GE Nuclear Energy

SUBJECT: Response to USNRC Request for Additional Information dated May 16, 2003

Response to NRC Request for Additional Information dated May 16, 2003

Request for Additional Information for General Electric - Morris Operation License Renewal Application

Calculations From Offsite Dose Calculation Manual

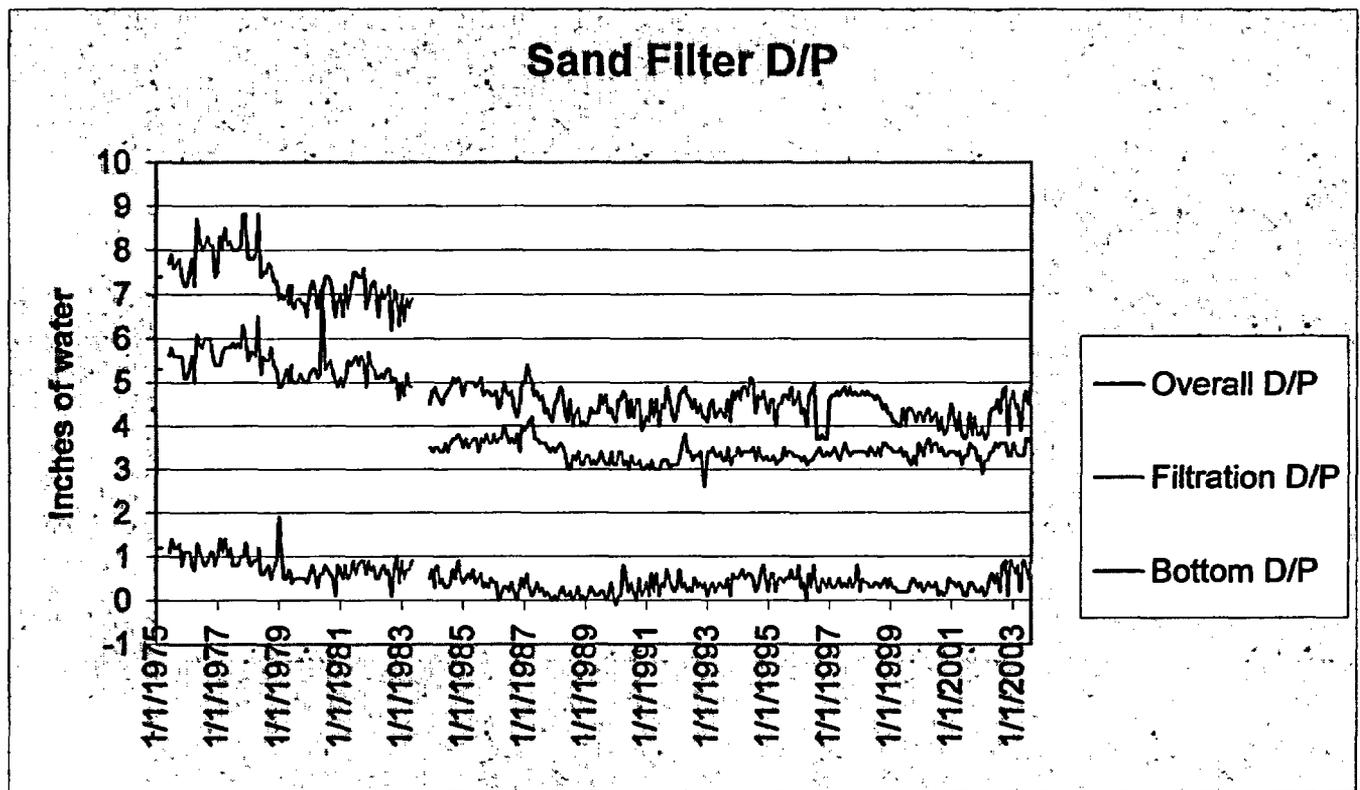
Response - The ventilation exhaust system is not required to maintain normal and accident doses below the limits in 10 CFR 72.104 and 10 CFR 72.106. Stack clogging would be very unlikely due to the physical construction of the system, and there is no screen in place to prevent clogging, however, there is a alternate port that can be used to either clean the stack, have a ground level release point, or erect a temporary stack.

This chart shows modified calculations for all accidents in section 8 of the CSAR that calculate exposures to the public. These are calculated using the Off Site Dose Calculation Manual for the GE Morris Operation using the most restrictive X/Q values for a ground level emergency release.

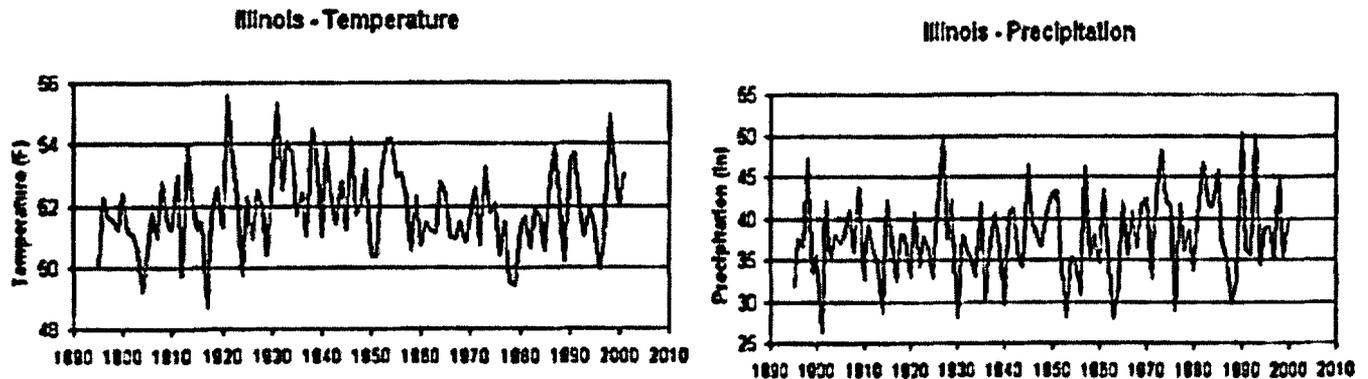
- a. Table 3-4 Aircraft flight information is from 1979;
- b. Table 3-6 Precipitation information is from 1964;
- c. Figure 3-8 Wind rose data is from 1971;
- d. Figures 3-3, 3-4, 3-5, and 3-6 Population Data is from 1990;
- e. Table 3-7 Thunderstorm activity information is from 1976;
- f. Table 3-8 Stability class and wind direction information is from 1974;
- g. Table 3-12 Water analysis information is from 1977; and
- h. Figure 7-1 History of Basin Water Activity ends in 1994.

Response – a. The aircraft flight data in Table 3-4 is referenced to VOR flight tracking. As per FAA regional office, since flights use GPS now, this system is no longer used and an update of the info is not possible. The information was retained in the CSAR to depict there are no scheduled flight lanes over GE-MO.
